ADDENDUM NO 2

Pavement Restoration & Recycled Water Extension 23/24 Maria Dr C16102248/C66501834

October 23, 2023

This Addendum No. 2 modifies the Bidding Documents for Pavement Restoration & Recycled Water Extension 23/24 Maria Dr. C16102248/C66501834. This addendum shall become part of the Contract, and all provisions of the Contract shall apply thereto. Bidders shall acknowledge all Addendums in the Bid Schedule.

9 BOX CULVERT OVER-CROSSING
 NO SCALE

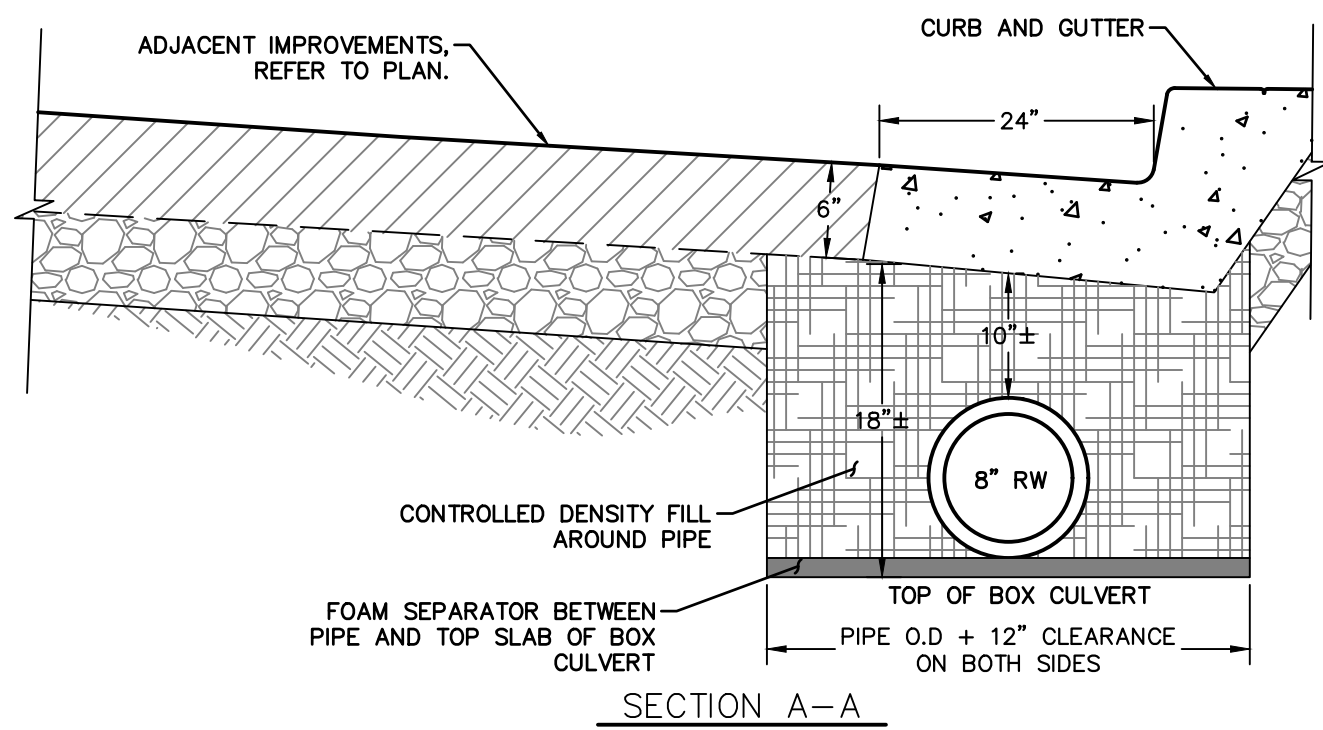
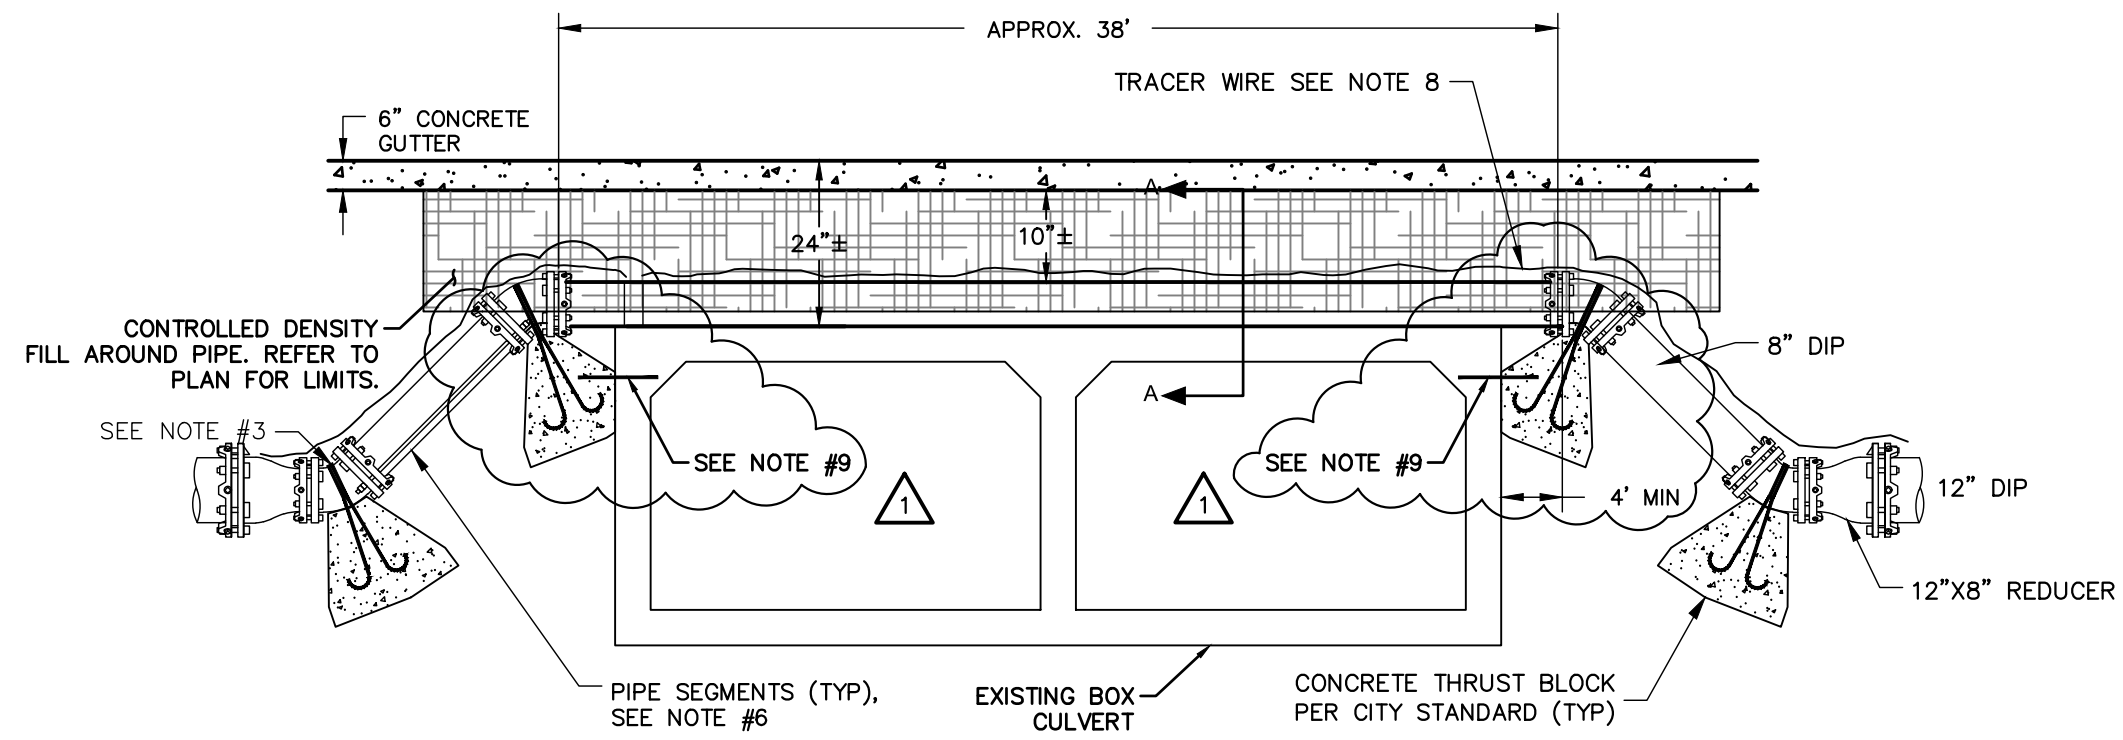
Regarding the box culvert crossing of a 38 ft. DIP (Bid Item #18). The detail indicates there are no joints. DIP comes in 20' lengths.

Refer to Revision 1 on Sheet 76 CD-4, included with Bid Addenda #2. "No joints" has been removed from the detail. Note 1 indicates that all pipes and fittings shall be wrapped in polyethylene. Additional thrust blocks are provided.

1. ALL PIPE AND FITTINGS SHALL BE CEMENT LINED OR EPOXY FUSION BONDED DUCTILE IRON CLASS 53 MINIMUM AND SHALL BE WRAPPED IN POLYETHYLENE PER WATER SYSTEM DESIGN GUIDELINES.
2. ONLY RESTRAINED FITTINGS, MECHANICAL JOINT, TIE RODS, MEGALUG (OR EQUAL), FLANGED MAY BE USED. ALL BENDS MUST BE RESTRAINED.
3. PIPES SHALL BE CONTINUOUS THROUGH FITTINGS NO PIPE SEGMENTS ARE ALLOWED.
4. ALL BENDS SHALL BE 45° OR 22 1-1/2° FITTINGS. 90° BEND ARE NOT ALLOWED.
5. REDUCED CLEARANCE MAY BE APPROVED BY THE PUBLIC WORKS & UTILITIES DEPARTMENT.
6. DUCTILE IRON TRANSITION COUPLINGS MAY BE ALLOWED WHEN THE NOMINAL PIPE SIZE IS THE SAME AND THE O.D. IS DIFFERENT.
7. ALL JOINTS WITHIN 50 FEET OF REDUCER SHALL BE RESTRAINED.
8. ALL HARDWARE IS TO BE TYPE 316 STAINLESS STEEL.
9. DOWEL AND EPOXY #4 REBAR INTO EXISTING BOX CULVERT A MINIMUM OF 3-INCHES.

REVISED STANDARD PLAN RSP A88A

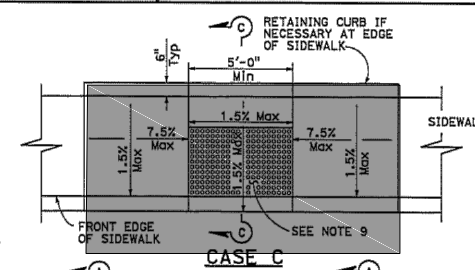
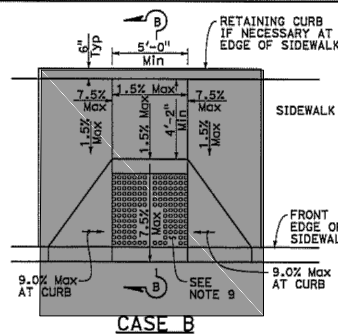
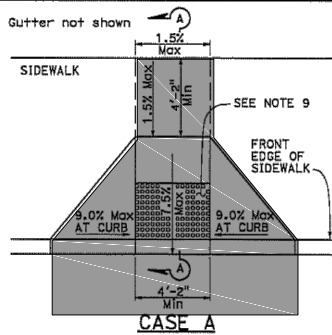
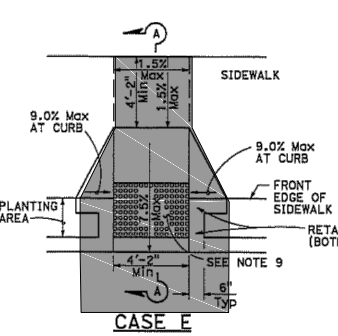
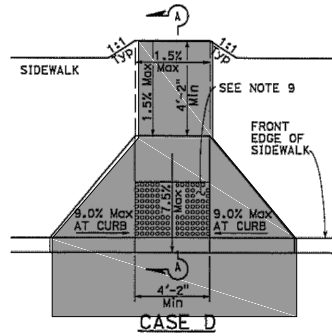
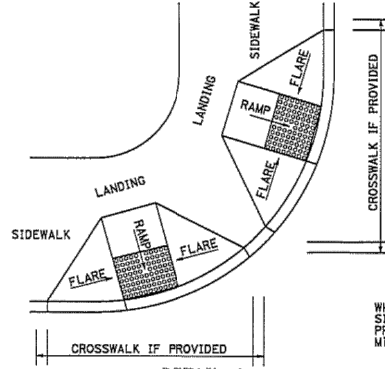
As written in Tech Specs Section 400, the area and scope limits for the curb ramps needs to be clarified. The specs indicate the ramps are to include “the curb and in front of the ramp on the entire curb return”, “five foot wide 6” AC or conc gutter conform,” as well as limits extending to “closest extension score marks....at grade break beyond landing”. With the various bid items for ramps listed as per EA, this leaves a significant amount of variability for each ramp. The C&G limits included in the ramps are not clear, and the total area of the ramp can vary substantially depending on score marks/grade break definition in the field.

Refer to the revised measurement and payment language in Tech Spec Section 400 and the Caltrans Revised Standard Plan RSP A88A markup. Temporary conforms will be included under the concrete curb, gutter, and valley gutter.

PAY LIMITS – APPLIES TO ALL CURB RAMPS INCLUDING MODIFIED CASE RAMPS

STANDARD TYPE "B"
CIP DRAINAGE INLET
STORM DRAIN

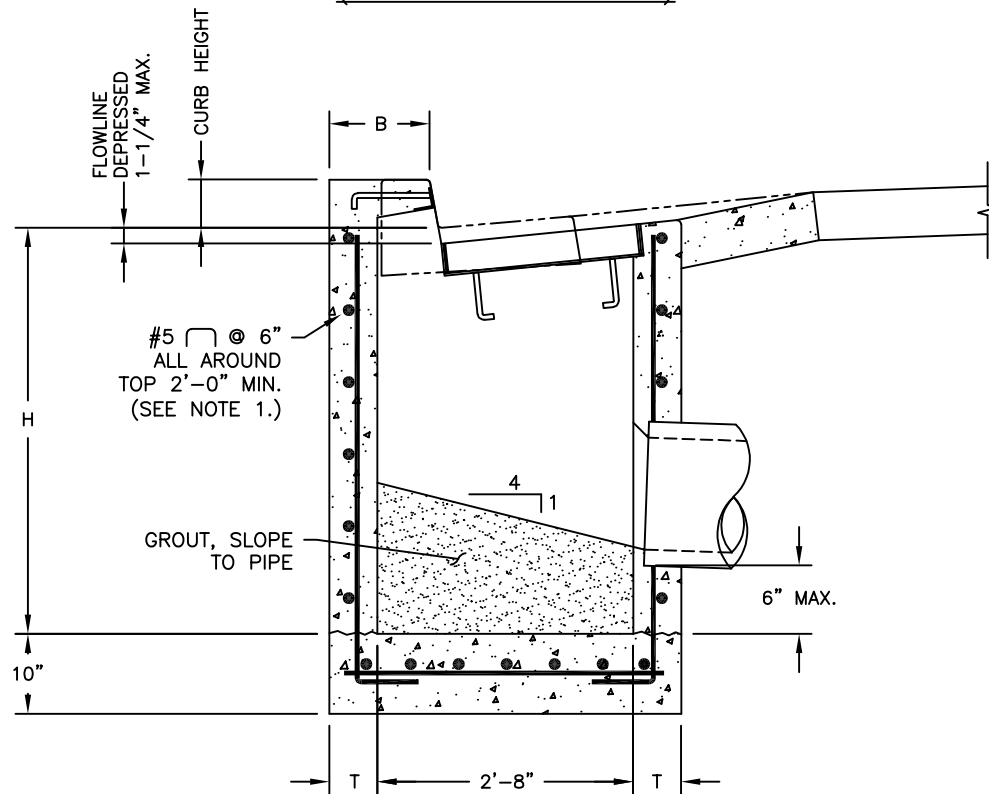
Question #3: Please confirm details 203.1, 408.1, 409.1 and 410.1.

See attached.
